E285 - EPA 2021 PACCAR MX Particulate Matter Sensor and Software Emissions Recall

E285

4/4/2022

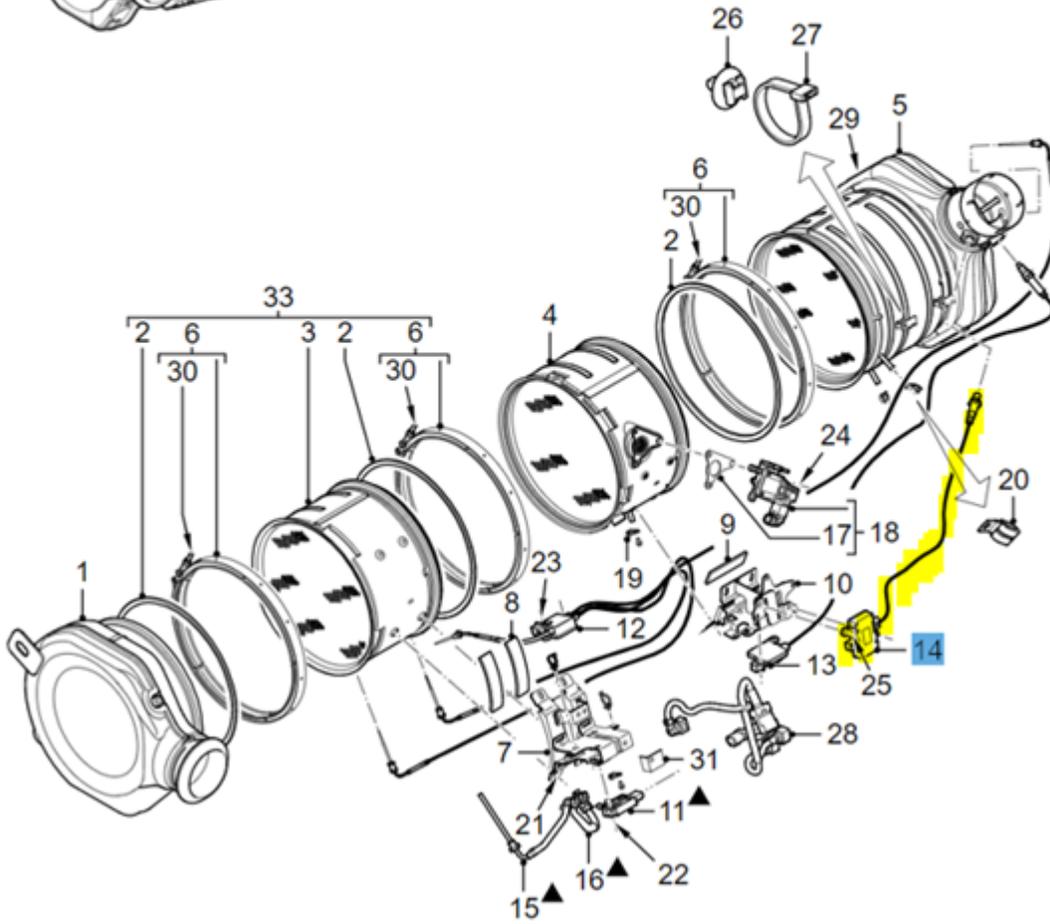
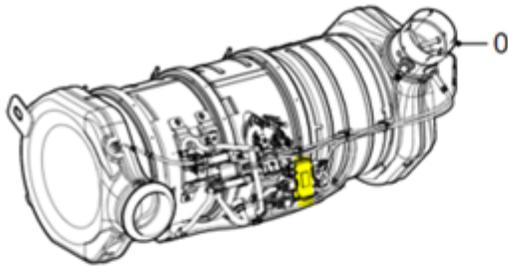
Ensure that the correct sensor is on-hand for each chassis scheduled before beginning work. Do not update the software before installing the sensor.

1. **To install the PM sensor, refer to RMI.**

2. **Update PCI-2 software**

- Ensure DAVIE4 is up to date
- Refer to bulletin E134 for information about programming a PACCAR MX engine.
